# HISTORIC LANDMARK COMMISSION STAFF REPORT

Cannon Office Building  
Minor Alterations  
PLNHLC2008-00591  
633 E. South Temple Street  
December 3, 2008

## ***Request***

2 PROPOSED ELEVATION -SOUTH  
H-1 1/8" = 1'-0"

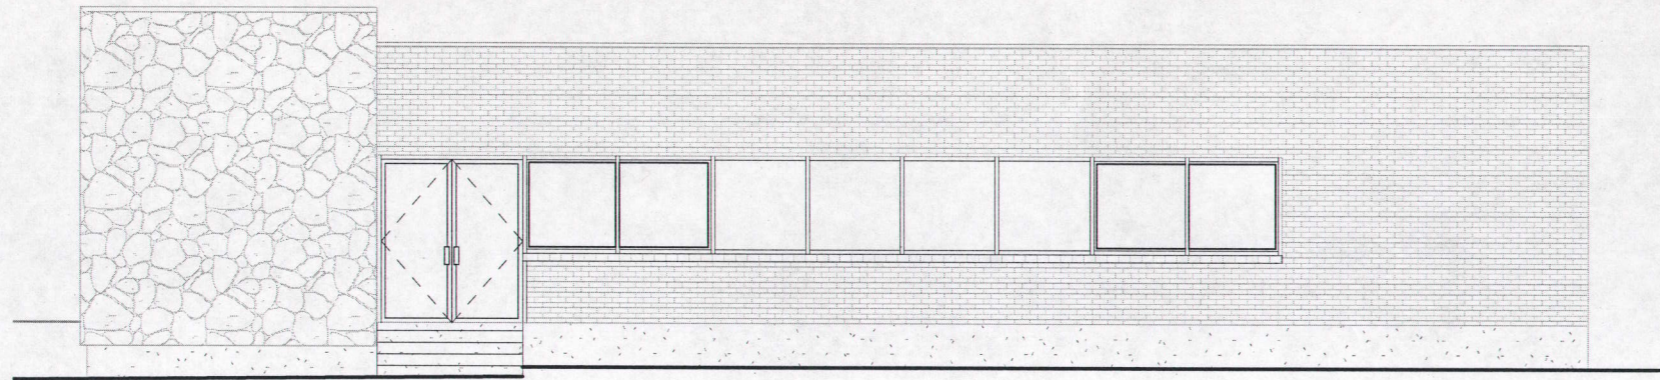
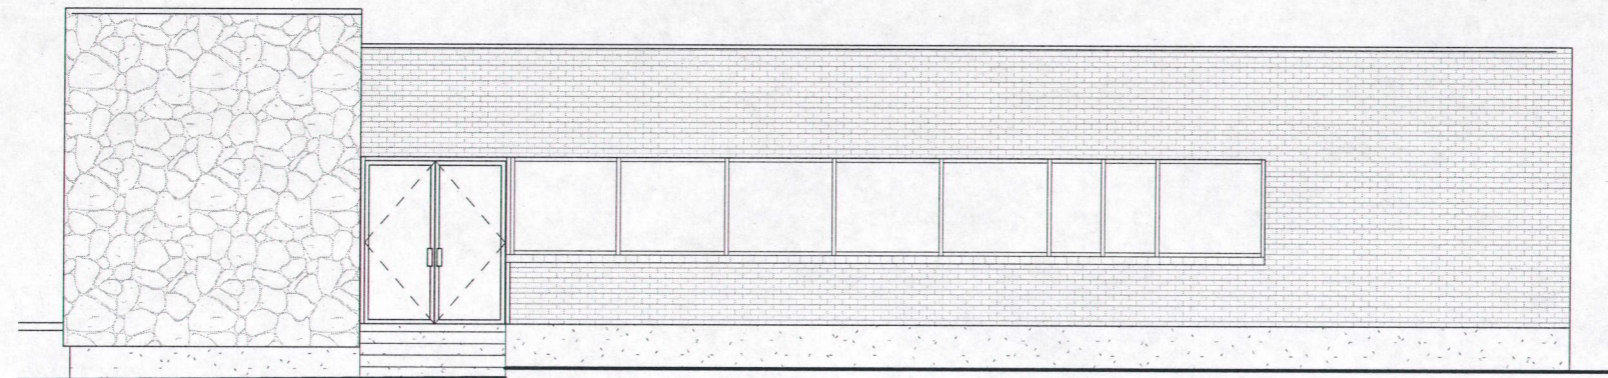
**Analysis:** The metal replacement windows use a size and proportion of window elements that does not match the appearance of the original windows.

**Analysis:** This building has generally maintained its architectural integrity over time. As part of the building's exterior features, the windows comprise a considerable amount of the historic fabric of the wall plane. Assuming that window replacement is an appropriate action, the proposed design of the replacement windows do not meet this standard as the distinctive size of the glazing and division in the eastern section of the strip window do not match the original design.

**Analysis:** Staff denied the request for metal replacement windows because they are not similar in appearance to the original metal windows as shown in Attachment A. The City's adopted design guidelines discuss replacement materials and more specifically, window treatment extensively and recommend that replacement windows must also be the same size and configuration as the historic windows.

Must the new window configuration EXACTLY match the existing in every respect in order to be administratively approved? The original layout had an anomaly where one pane was divided to make an operable window (see attached). I maintain that irregularity is not key to the character of the building, as it does not tie into or relate to any other element of the façade. I am basically taking the same number of panes and making them equal width. The proposed window is in keeping with the character of the building (again, see attached drawing.)

The number and arrangement of windows in a building wall, particularly in a primary façade, are important in defining the overall character of the building. Therefore, I will not administratively approve the proposed window replacement. You might want to consider a new window that conveys the same visual appearance as the original. This action would meet the Design Guidelines and could be administratively approved. Administrative decisions may be appealed to the Historic Landmark Commission within 30 days of the date of this decision. An application is available online at [www.slcgov.com/ced/planning](http://www.slcgov.com/ced/planning). The Historic Landmark Commission meets on the first Wednesday of the month. Would you like me to move forward with the COA for the other improvements? Thank you.

Yes it is slightly different. We want two operable windows (one for each office) vs. the one original. Are you requiring it to be exactly the same?

Please review the south elevation drawings. The configuration of the windows, size and number of panes of glass, appears different than the original design. Thanks.
